Evaluation of proposed move for Water Right No. 15465

Proposed: Move water right no. 15465 to a new well location, 454 ft to the northeast.

Data Set: C:\Users\trevora\Documents\2024_moves\15465\15465 Current.aqt
 Date: 03/07/24 Time: 11:44:01

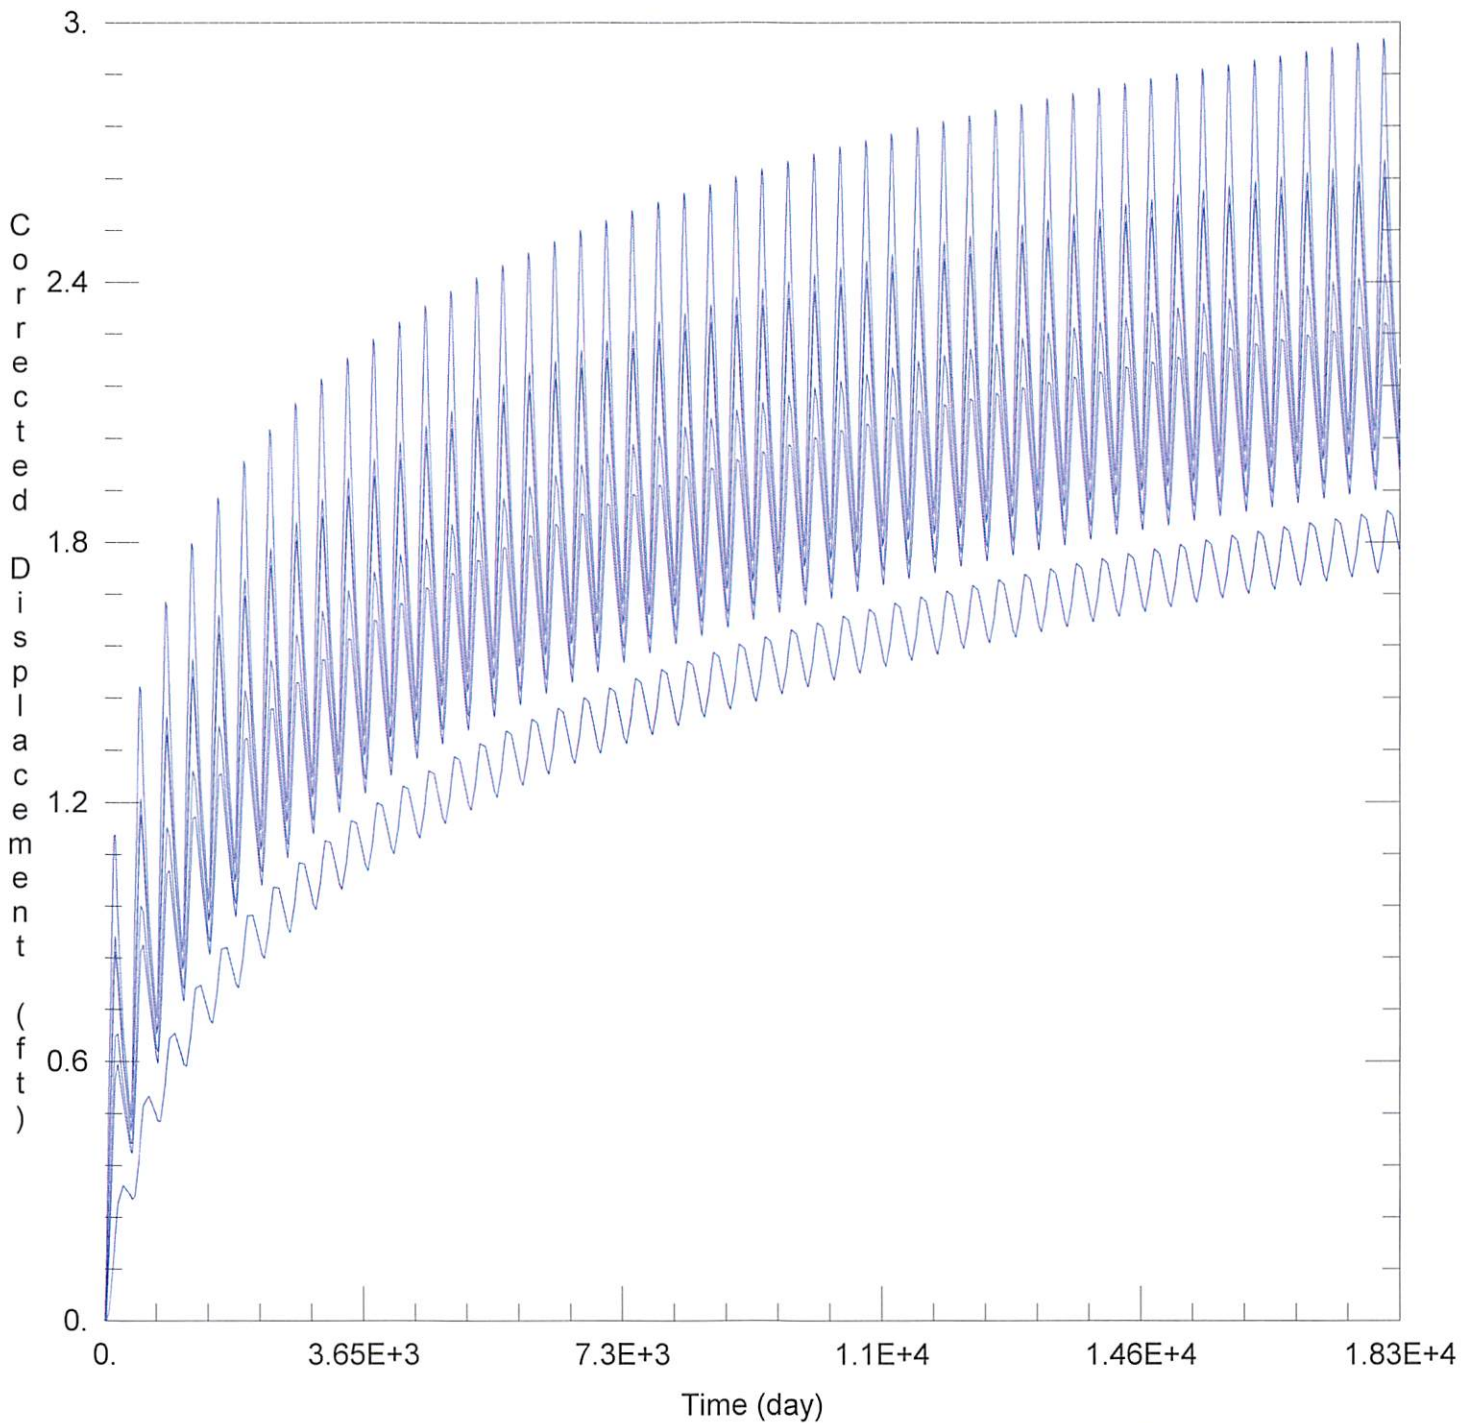
15165 & 15729:	Drawdown from current location = 2.42 ft
	Drawdown from proposed location = 6.02 ft
	Net drawdown = 3.6 ft
30169:	Drawdown from current location = 2.68 ft
	Drawdown from proposed location = 7.44 ft
	Net drawdown = 4.8 ft

Net drawdown exceeds the drawdown allowance for the wells authorized under water right nos. 15165 & 15729, 30169, 18744, 14185, and 33246. Critical well analysis was performed for those wells.
